Review of Preston New Road Environmental Statement

Technical report

Health Impact Assessment Support, shale gas exploration

Lancashire County Council

Figure 3-1: South Blackpool development hub potential expansion

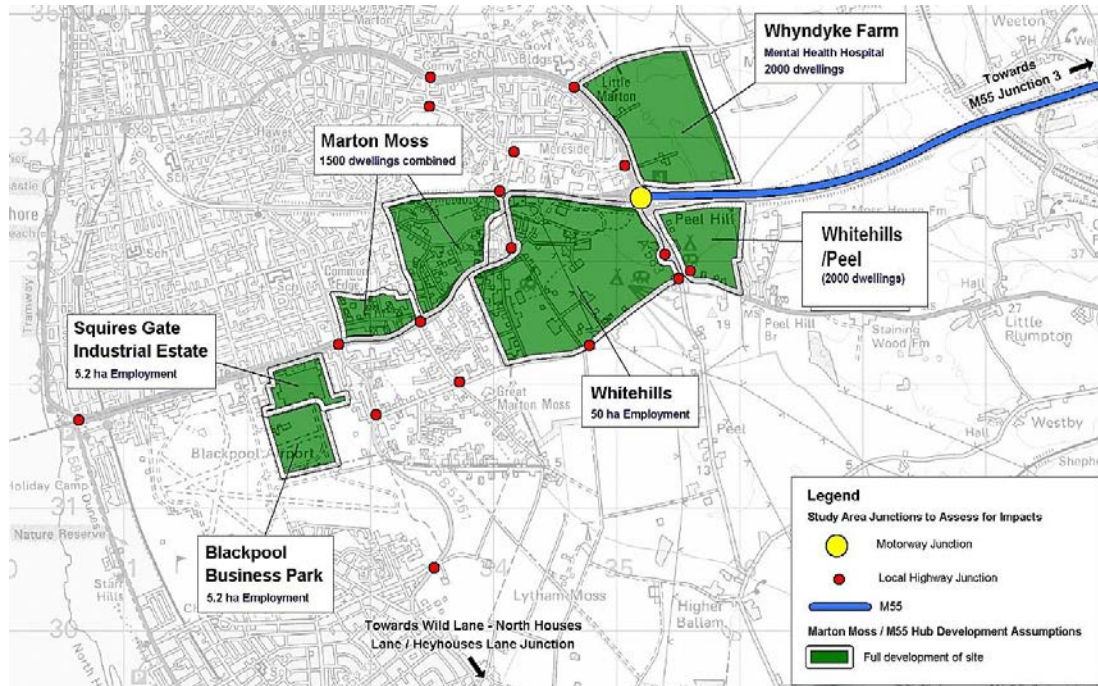
- 3.3.9 A potential gap in the cumulative impacts section of the ES is the proposal for the 'development hub' of as many as 5,500 new homes near the A55 interchange, to the east of Blackpool. The expansion could also include around 60 ha or employment land and a

Mental Health Hospital at Whyndyke Farm (19). The Blackpool emerging Core Strategy (20) Policy CS25 describes South Blackpool housing growth, including lands around Junction 4 of the M55. Policy CS24 also supports employment growth for this area.

Figure 3-2: Noise from hydraulic fracturing pumping operations calculated at ground floor level (to reflect daytime impacts)

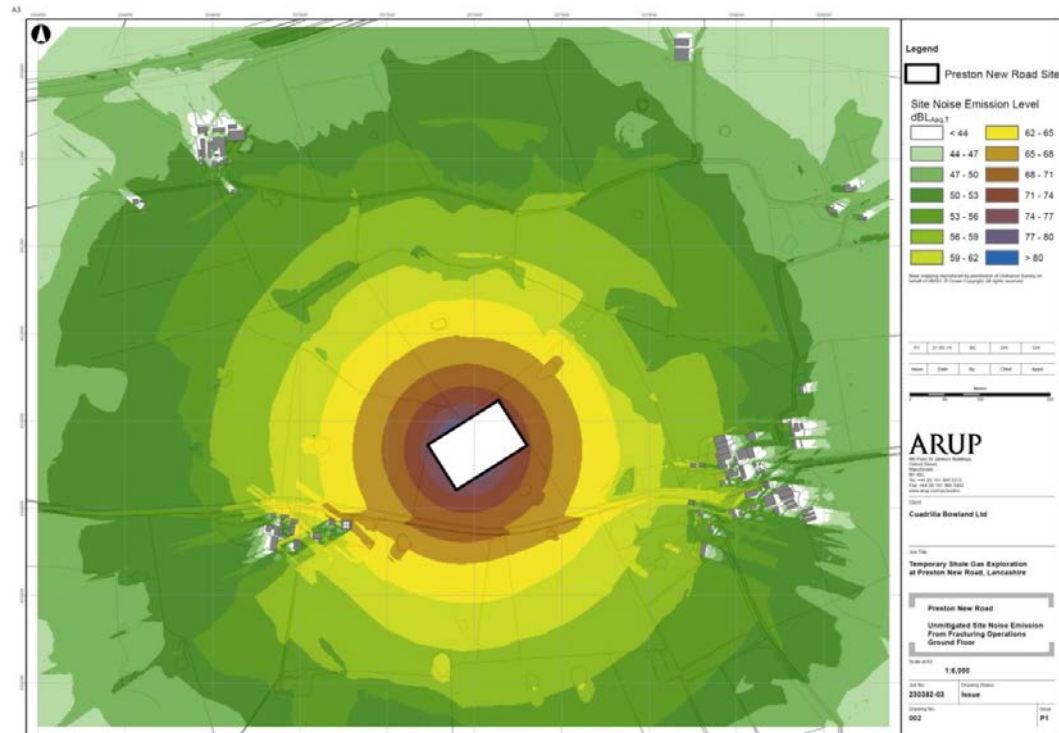
after 13:00 and Sunday. Hydraulic fracturing equipment noise is a potential impact the HIA may wish to consider in more detail.

- 3.5.20 Figure 3-2 is reproduced from ES Appendix P to show the potentially most significant noise impact of the project, hydraulic fracturing.

- 3.5.24 As the thresholds applied by the ES suggest there will be no significant impacts, the noise chapter only specifies minimal mitigation. This includes usual best practice for operating machinery and vehicles; selection of quieter plant and equipment; and as far as is practicable, placing plant in screened positions to minimise noise emission in the direction of dwellings. As an HIA can consider current levels of understanding of impacts on health, as yet not incorporated into legal limits it may be appropriate for the application to consider noise attenuating screening or other mitigation. Although there may be some visual impact, noise barriers should be a relatively straight forward addition (unless a significant noise source exists high on the drilling rig or other plant). The ES states that the site and access road will be secured by a 4m high welded mesh security fence. A solid rather than chain link type fence could contribute to noise mitigation, a specialised noise barrier more so.
